Title of Change:	Long boot issue on the Ezairo 5920 hybrid for 0W635-004-XTP.	
Proposed first ship date:	26 July 2018	
Contact information:	Contact your local ON Semiconductor Sales Office or < christophe.waelchli@onsemi.com >	
Samples:	Contact your local ON Semiconductor Sales Office or < christophe.waelchli@onsemi.com >	
Additional Reliability Data:	Contact your local ON Semiconductor Sales Office or < paul.syndergaard@onsemi.com >	
Type of notification:	This is a Final Product/Process Change Notification (FPCN) sent to customers. FPCNs are issued 90 days prior to implementation of the change. ON Semiconductor will consider this change accepted, unless an inquiry is made in writing within 30 days of delivery of this notice. To do so, contact < PCN.Support@onsemi.com >.	
Change Part Identification:	A new OPN will be available and the chip ID will be modified as follow: Old OPN: 0W635-004-XTP / Old chip ID: 1.02.00. New OPN: 0W635-006-XTP / New chip ID: 1.02.10.

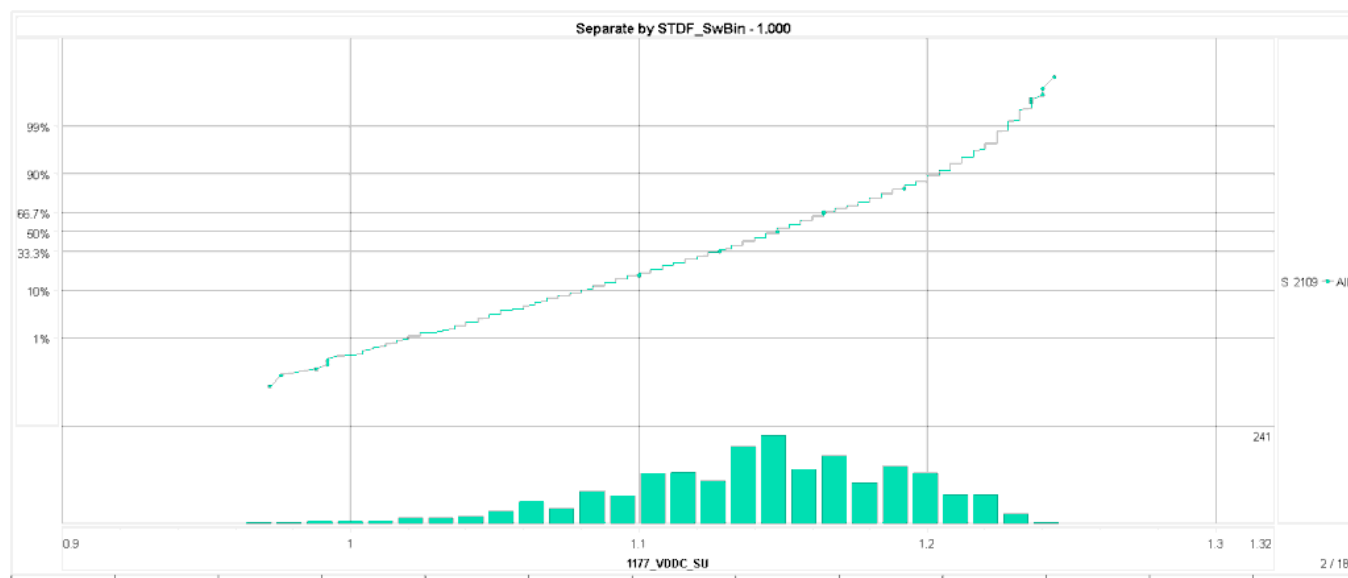
The following graph shows the VDDC startup voltage after 100 ms on the 0W635-006-XTP. After 100 ms, VDDC reaches its controlled final value on all tested units.
